L624-  
A.05.16

**To:** Official After Sales Network  
**Subject:** Haldex control unit cover.  
**Date:** March 18,2016  
**Pages:** 2

**Model.**  
Huracàn Coupè

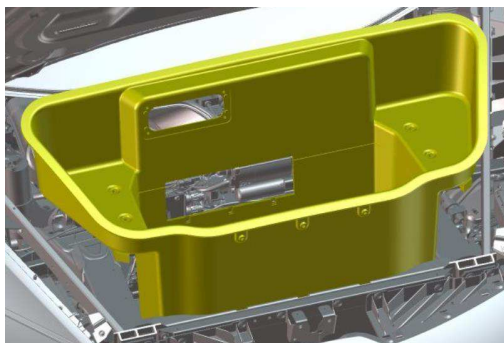
Remove the screws which secure the Haldex control unit.

Screw tightening;  
torque: **30Nm**

4. Fit the cover with the clip as shown below.

5. Install the cover on the Haldex control unit and check the clip is correctly embedded.
